4 February 2003
Reference: 143.65

Re: Response to Public Comments
Draft Phase IV Remedy Implementation Plan
Former Raytheon Facility
430 Boston Post Road
Wayland, Massachusetts (the "Site")
Permit No. 133939/RTN 3-13302

On behalf of Raytheon Company, Environmental Resources Management (ERM) has prepared this letter providing responses to comments prepared by CMG Environmental, Inc. (CMG), consultant to the Town of Wayland, and Mr. Stan Robinson regarding the Draft Phase IV Remedy Implementation Plan (RIP), dated 27 November 2002. CMG's comment letter, dated 17 December 2002, contains 15 comments concerning previous assessment activities and the Draft Phase IV RIP. An additional five comments were received on 23 December 2002 from Mr. Stan Robinson. This response letter includes relevant portions of each comment in italics and responses in plain text.

Attachments: Figure 1 Site Plan

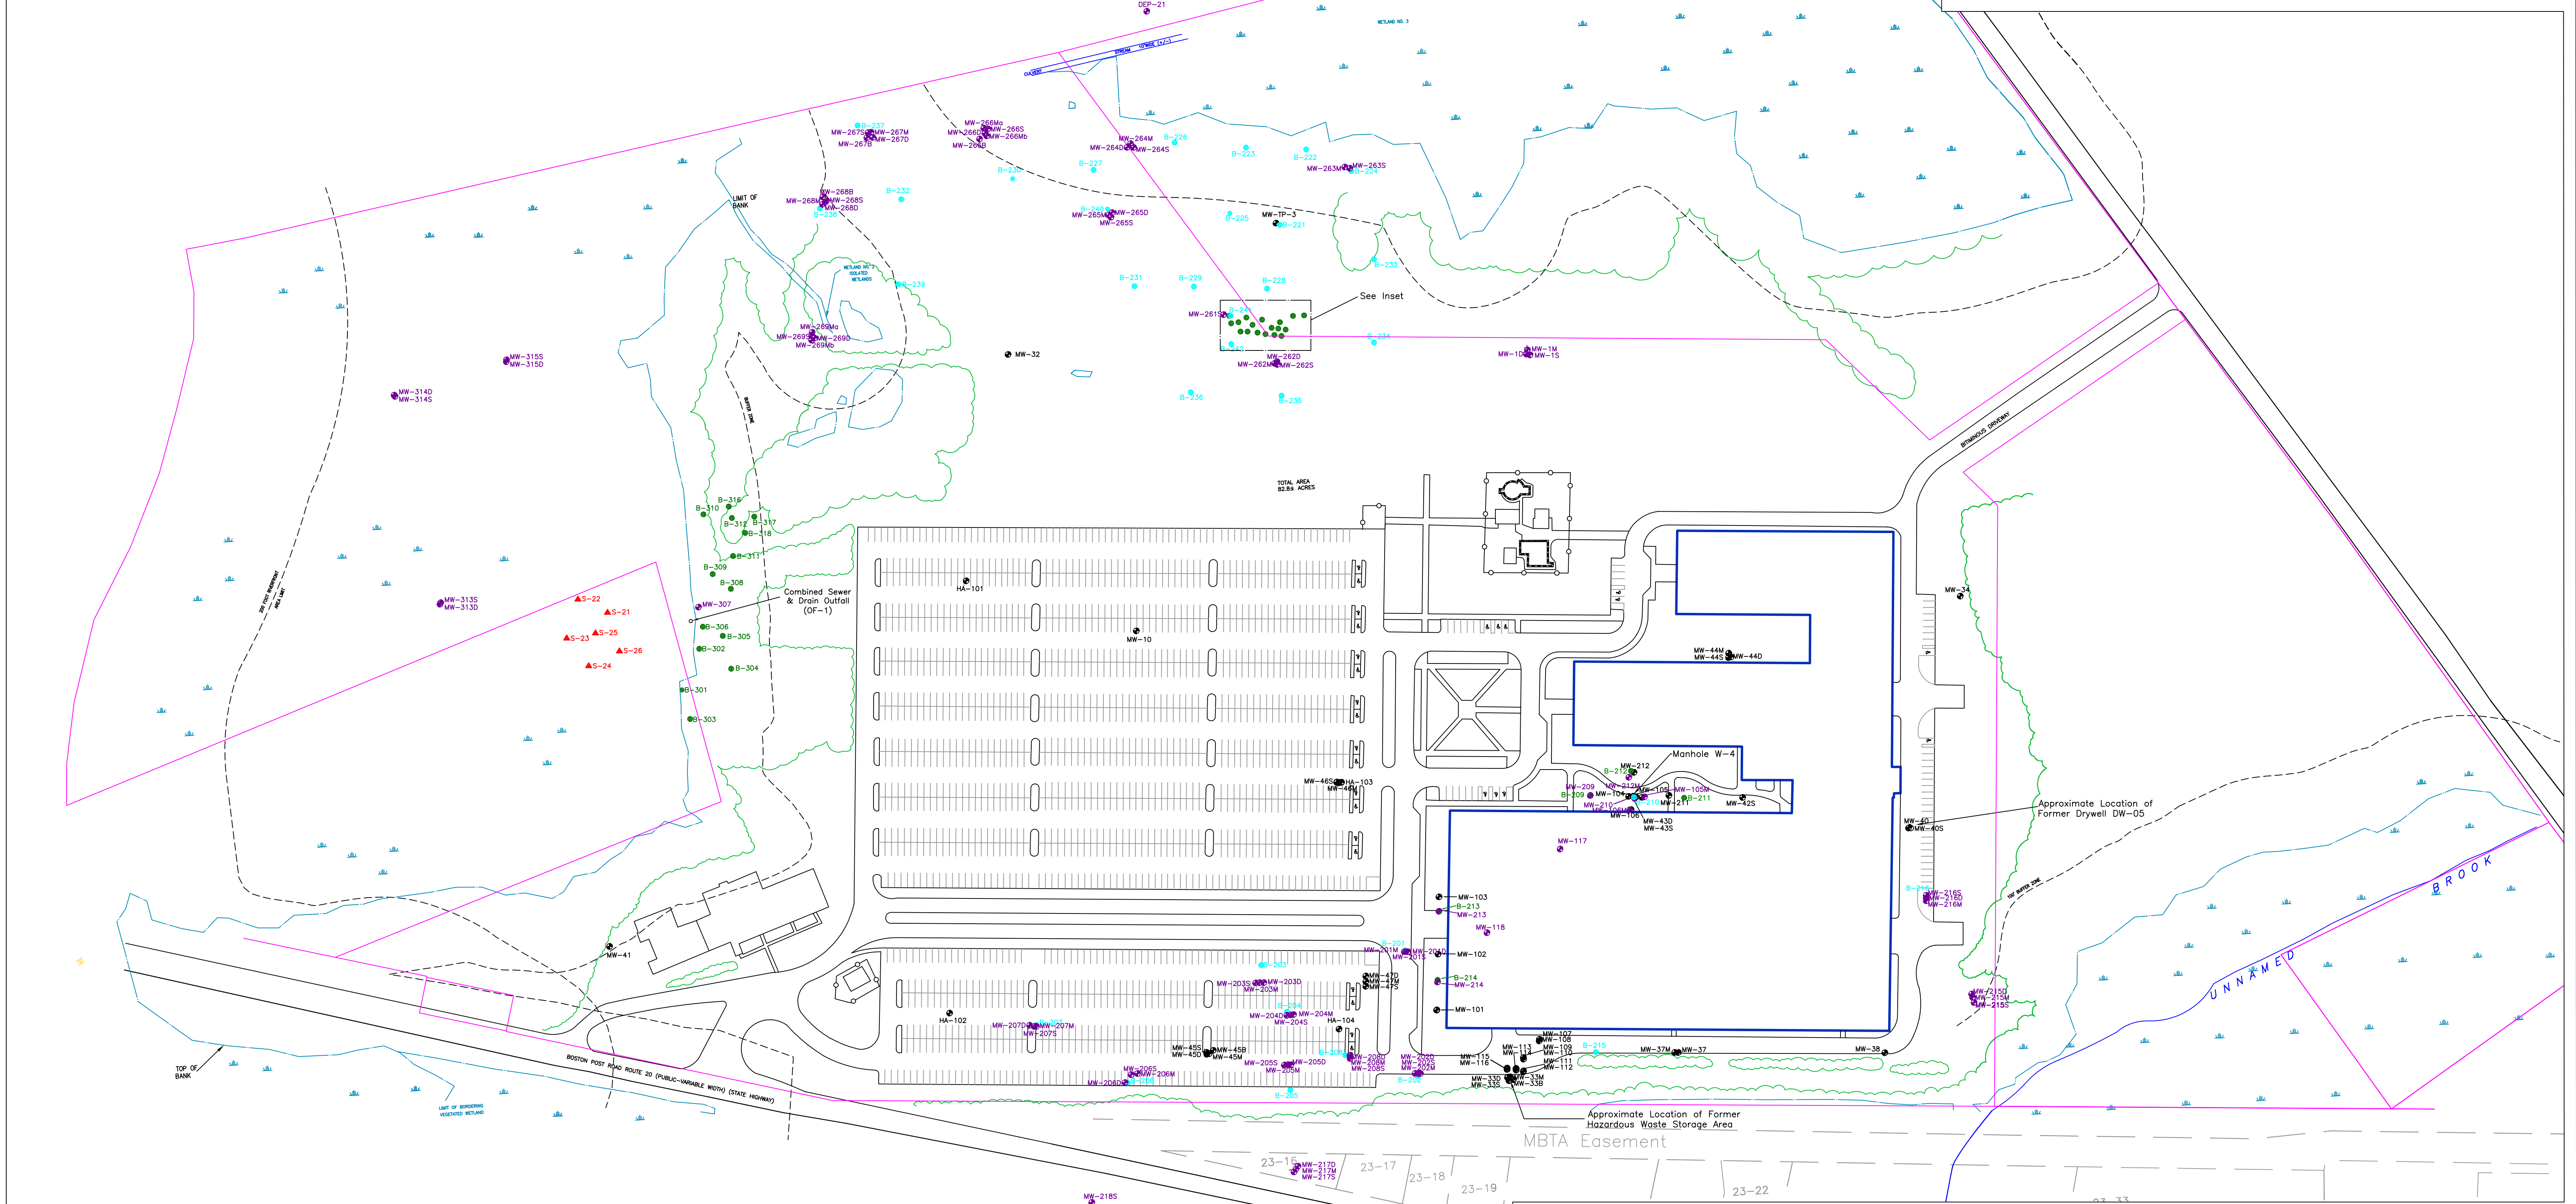
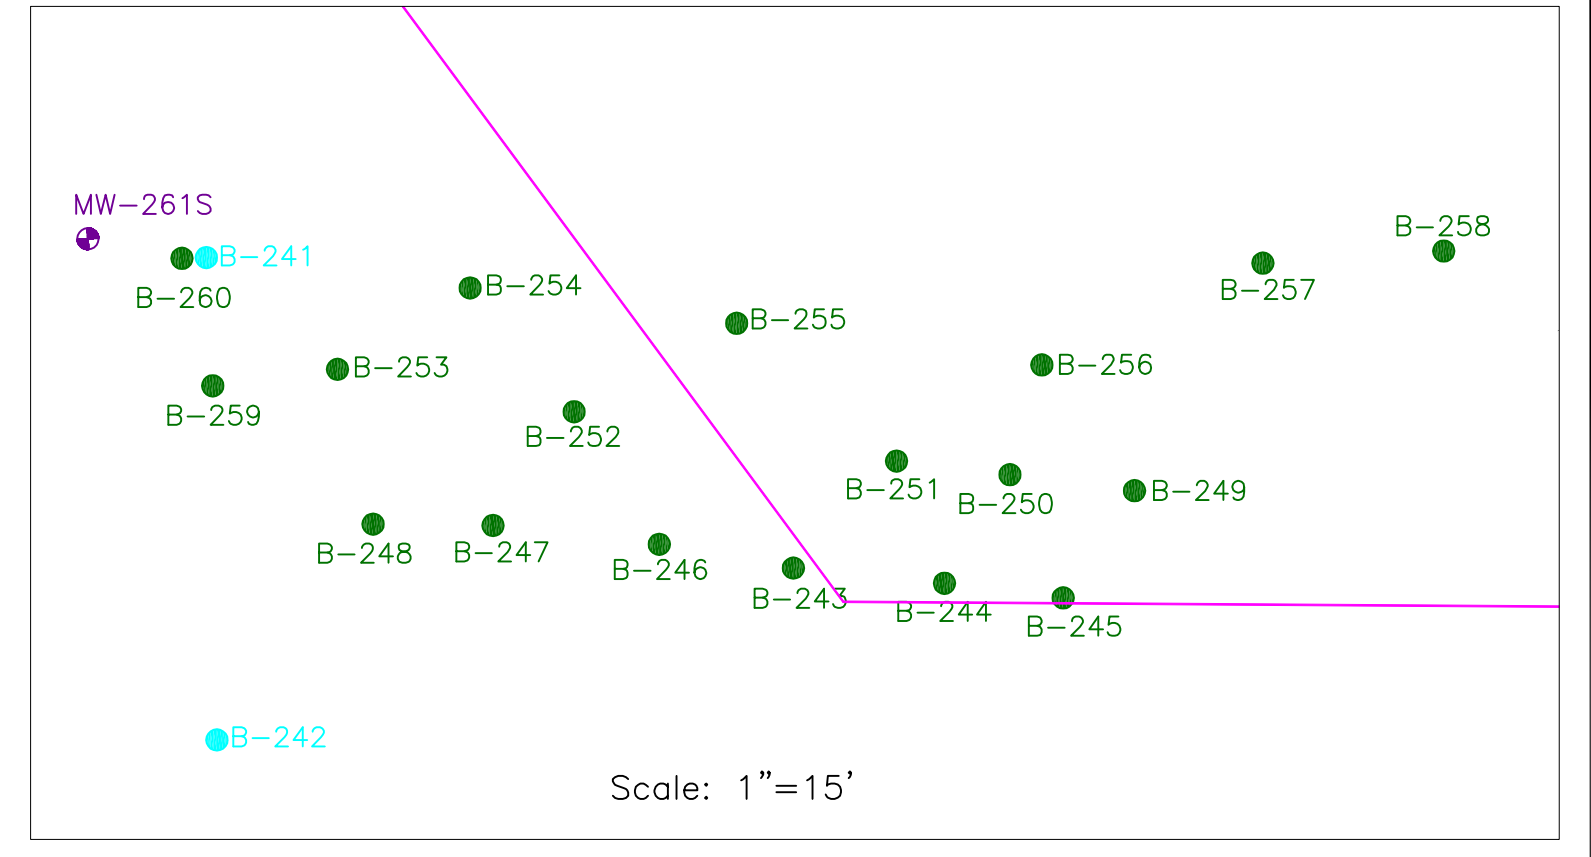
letter, they indicated nine boring/monitoring well locations. Wayland concurs with the placement of eight of these locations (designated P-1 through P-7 and P-9). However, the Town believes that location P-8 is too far to the southwest for assessment purposes, based on the field data from this past summer. Furthermore, we recommend that Raytheon place another sample point north of previous locations B-230 and between B-226 and B-237.

At the Public Involvement Plan (PIP) meeting on December 12, 2002, Mr. Joseph Fiacco and Mr. John Drobinski of ERM informed me that you had made adjustments in the proposed boring locations based on field observations that are essentially in conformance with this comment.

We appreciate your input regarding the location of new monitoring wells in the northern portion of the site. During the initial phase of the drilling program, similar observations were made and some of the monitoring wells were relocated, as we previously discussed. Attached please find an updated site plan showing the surveyed locations of the wells installed during December 2002 in the northern portion of the Site.
